RE: SUB 2000-55 -- Final Plat of Maple Shade Addition

STAFF REPORT

CASE NUMBER: SUB 2000-55 -- MAPLE SHADE ADDITION

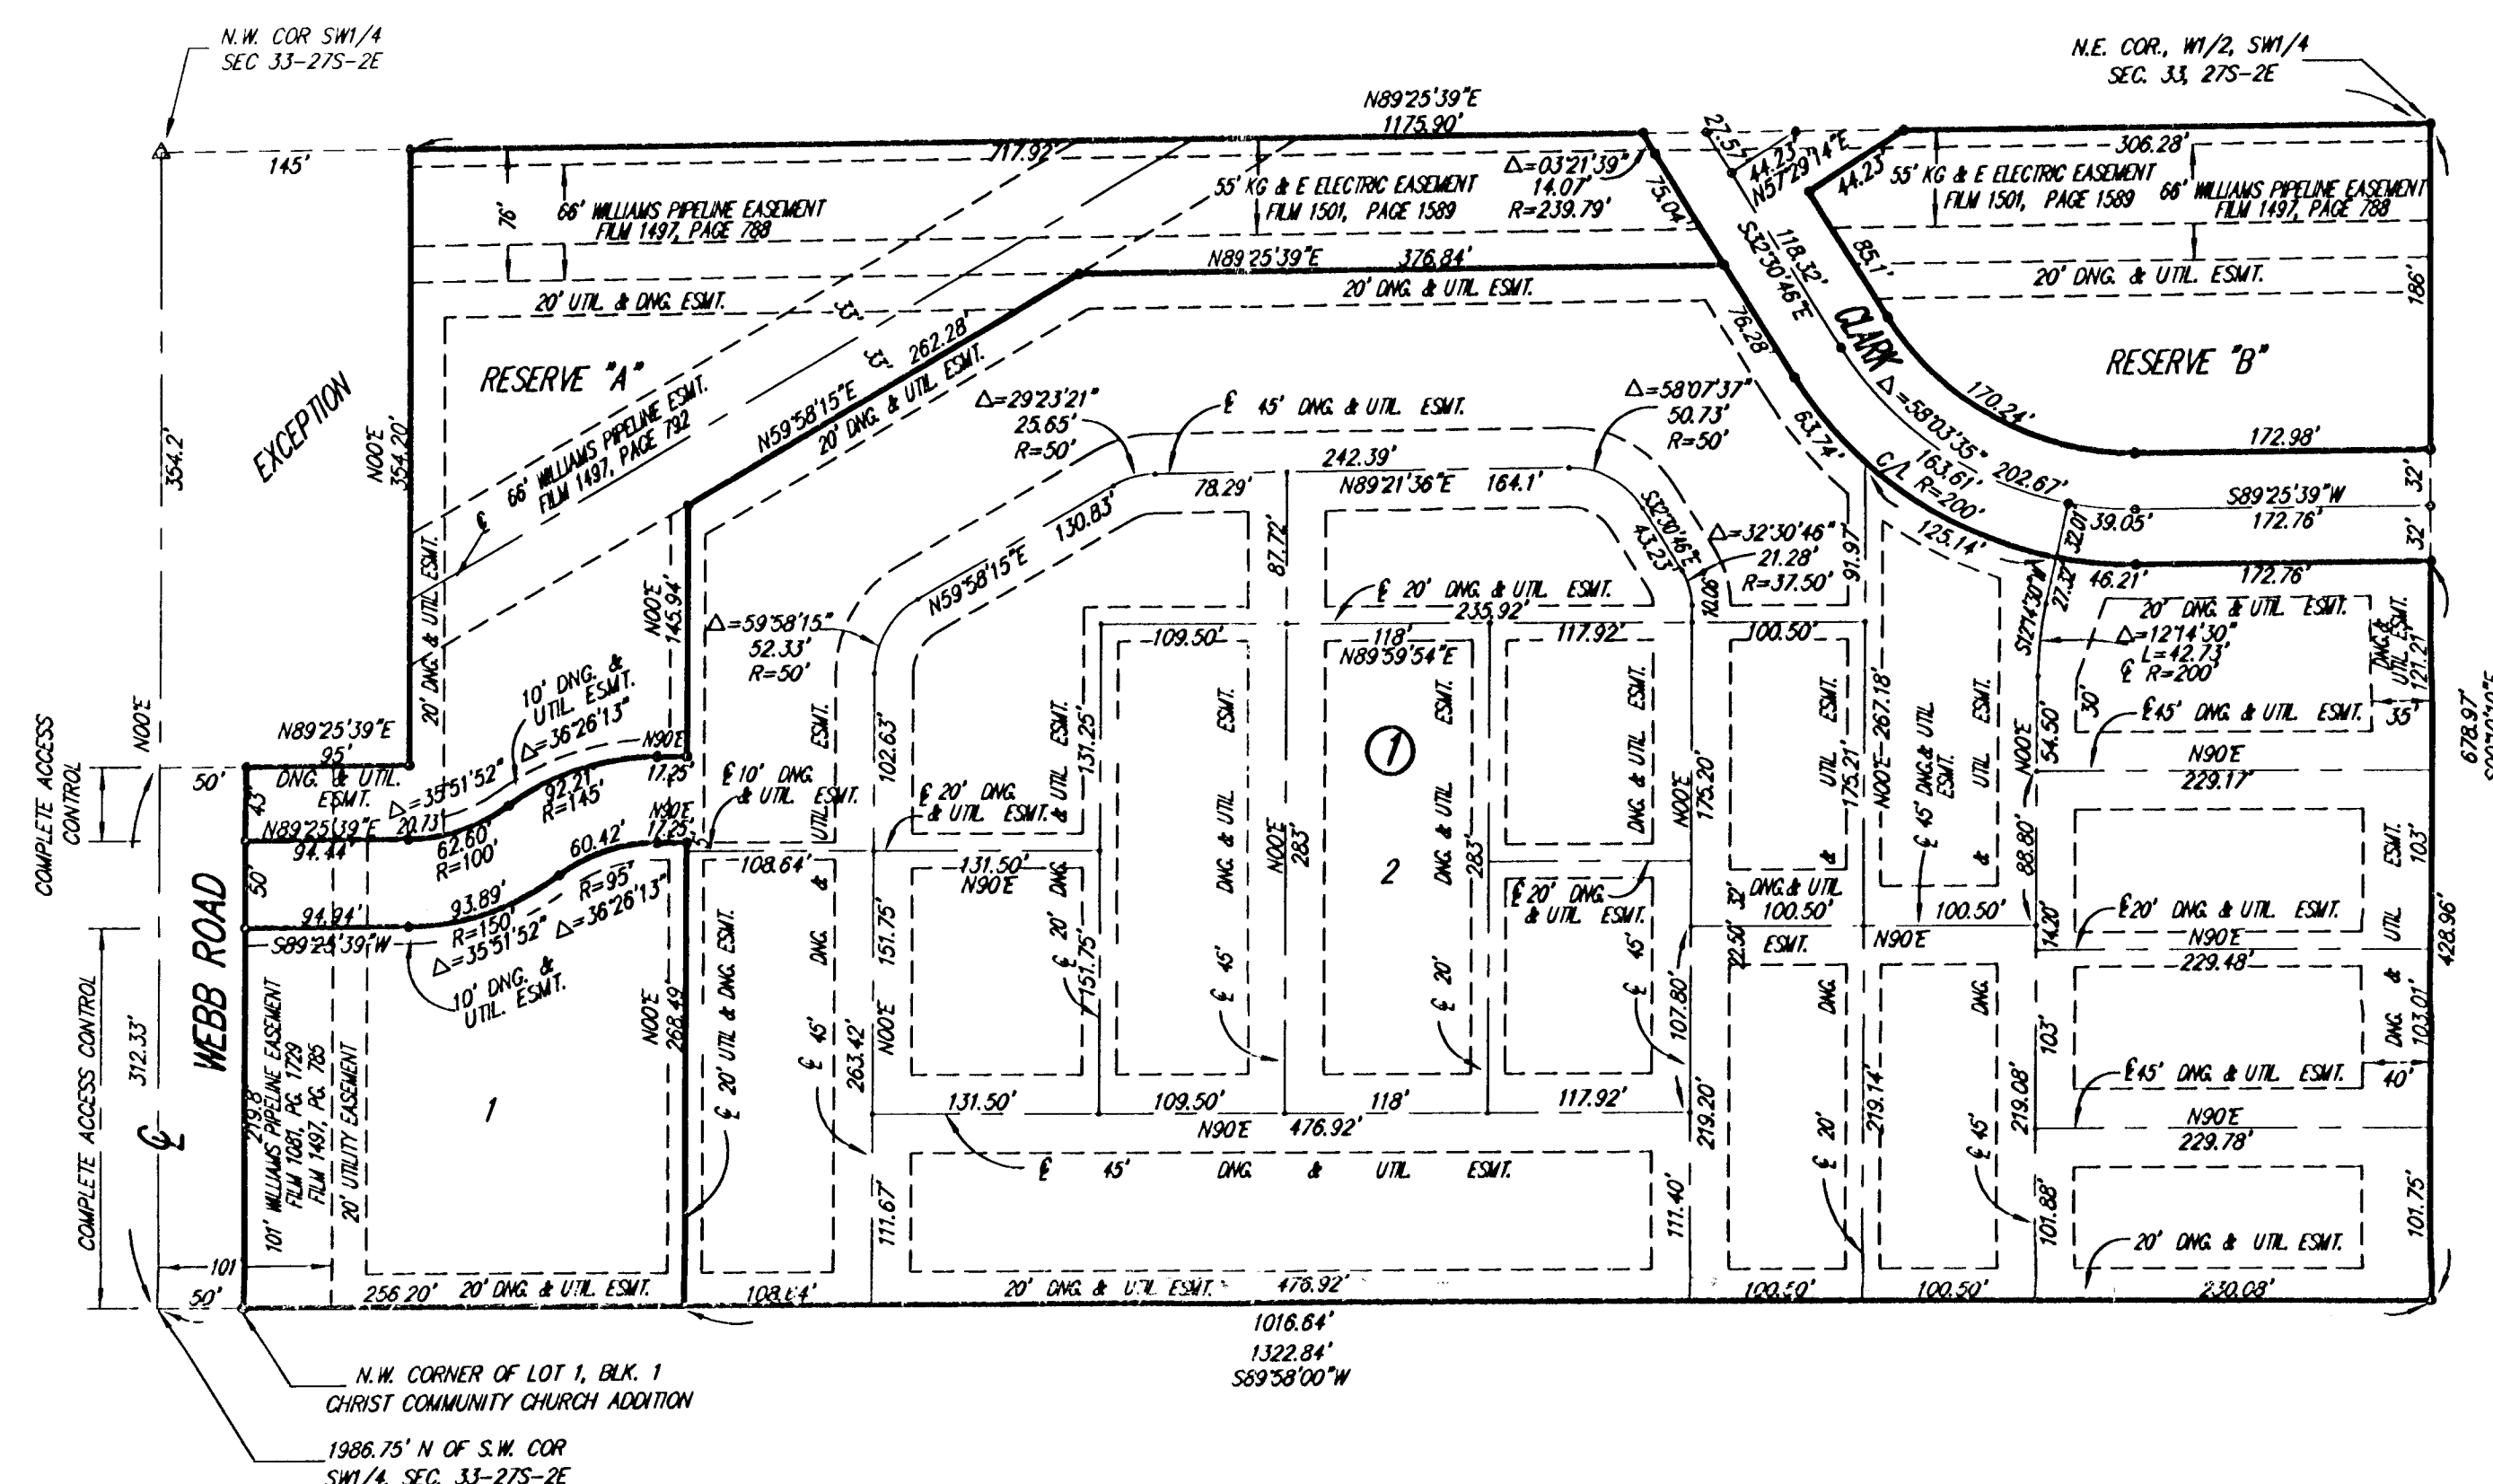
- A. As this site is adjacent to Wichita's City limits, the Applicant shall submit a request for annexation. Prior to this plat being scheduled for City Council review, annexation of the site will need to be completed.

- B. This plat will be subject to approval of the associated zone change and any related conditions of such a zone change.
- C. The applicant shall guarantee the extension of sanitary sewer to serve the lots being platted. This guarantee shall be with the City for service through the Four Mile Creek sanitary sewer system. County Engineering requests a sanitary sewer layout.

- D. The applicant shall guarantee the extension of City water to serve this site.
- E. If improvements are guaranteed by petition, a notarized certificate listing the petitions shall be submitted to the Planning Department for recording.

- F. City Engineering needs to comment on the need for any additional guarantees or easements. An off-site drainage easement is requested unless this Addition is platted concurrently with Brentwood South Addition to the east. A drainage guarantee is required.

- G. City Engineering needs to comment on the status of the applicant's drainage plan. On-site detention will be needed on the final drainage plan.
- H. The plat's text shall include ownership and maintenance responsibilities of the reserves.

- M. The applicant shall submit a copy of the instrument which establishes the pipeline easements on the property, which verifies that the easements shown are sufficient and that utilities may be located adjacent to and within the easements.

- N. The applicant's agent shall determine any setback requirements for the pipelines by researching the text of the pipeline agreements. If a setback from the pipeline easements is provided for in the pipeline easement agreements, it shall be indicated on the face of the plat.

- O. The Applicant shall guarantee the paving of the proposed streets. The guarantee shall also provide for sidewalks on the south side of Clark.
- P. The paving guarantee shall include the installation of a temporary turnaround at the terminus of Clark at the plat's east line unless the abutting street to the east has been constructed. The temporary turnaround shall be established by separate instrument.

- Q. City Fire Department should comment on the plat's street names. Stoneybrook should be revised to "Clark".

STAFF COMMENTS:

- A. As this site is adjacent to Wichita's City limits, the Applicant shall submit a request for annexation. Prior to this plat being scheduled for City Council review, annexation of the site will need to be completed.

- B. This plat will be subject to approval of the associated zone change and any related conditions of such a zone change.
- C. The applicant shall guarantee the extension of sanitary sewer to serve the lots being platted. This guarantee shall be with the City for service through the Four Mile Creek sanitary sewer system. County Engineering requests a sanitary sewer layout.

- F. City Engineering needs to comment on the need for any additional guarantees or easements. An off-site drainage easement is requested unless this Addition is platted concurrently with Brentwood South Addition to the east. A drainage guarantee is required.

- G. City Engineering needs to comment on the status of the applicant's drainage plan. On-site detention will be needed on the final drainage plan.
- H. The plat's text shall include ownership and maintenance responsibilities of the reserves.

- M. The applicant shall submit a copy of the instrument which establishes the pipeline easements on the property, which verifies that the easements shown are sufficient and that utilities may be located adjacent to and within the easements.

- N. The applicant's agent shall determine any setback requirements for the pipelines by researching the text of the pipeline agreements. If a setback from the pipeline easements is provided for in the pipeline easement agreements, it shall be indicated on the face of the plat.

- O. The Applicant shall guarantee the paving of the proposed streets. The guarantee shall also provide for sidewalks on the south side of Clark.
- P. The paving guarantee shall include the installation of a temporary turnaround at the terminus of Clark at the plat's east line unless the abutting street to the east has been constructed. The temporary turnaround shall be established by separate instrument.

- Q. City Fire Department should comment on the plat's street names. Stoneybrook should be revised to "Clark".

The street name has been revised as requested.
- R. A Protective Overlay Certificate shall be submitted to MAPD prior to City Council consideration, identifying the approved Protective Overlay (referenced as P-O #83) and its special conditions for development on this property.
- S. The plat's text shall include language that a drainage plan has been developed for the plat and that all drainage easements, rights-of-way, or reserves shall remain at established grades or as modified with the approval of the applicable City or County Engineer, and unobstructed to allow for the conveyance of stormwater.

The street name has been revised as requested.
- R. A Protective Overlay Certificate shall be submitted to MAPD prior to City Council consideration, identifying the approved Protective Overlay (referenced as P-O #83) and its special conditions for development on this property.
